## **FIELD SERVICE BULLETIN**

FSB Number: LVCCFSB2006-001  
Authors: Darwin Garcia  
Date: January 9, 2006  
Total No. of Pages: 3  
Subject: **V3 Blotch (Wet Spot) Display**  
Model Affected: **V3**  
Level of Repair: 2

#### **Main Lens**

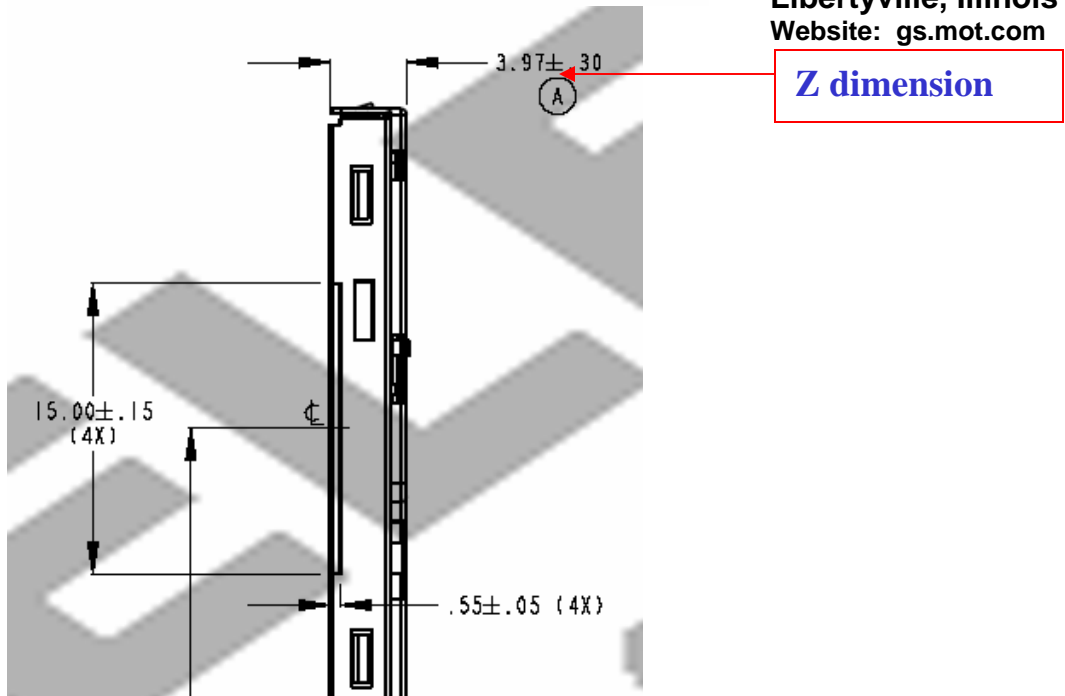
- Second Surface Coating
  - All blotch field failures have the Rev E main lens which has an Anti-Glare coating.
- Adhesive
  - Adhesive was strengthened from Rev D to Rev E to prevent lens lift problem

**Solution**

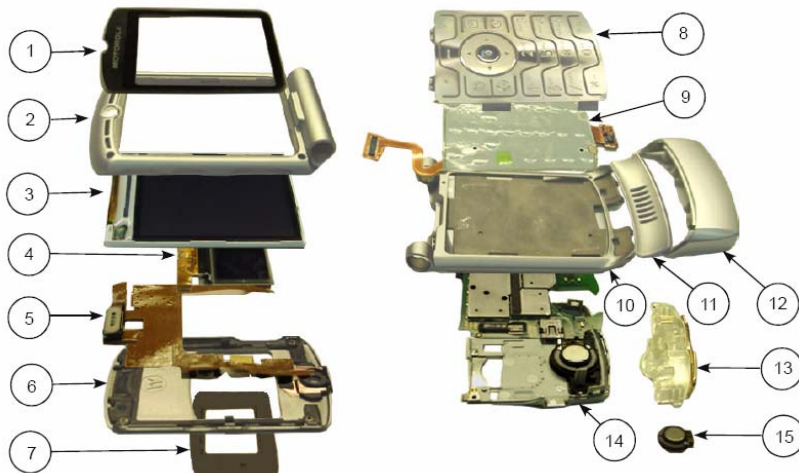
Further analysis has shown that disassembling the flip and replacing the main lens (same Rev E) is a sufficient repair action.

Sharp displays (7290086N02) are within the original specification as no waiver has been issued.

Sanyo (7290086N01) will fix out of spec displays on Razr05 displays in January.

When servicing any V3 customer phones with described issue, replace the main lens (1 = 6190016N03).
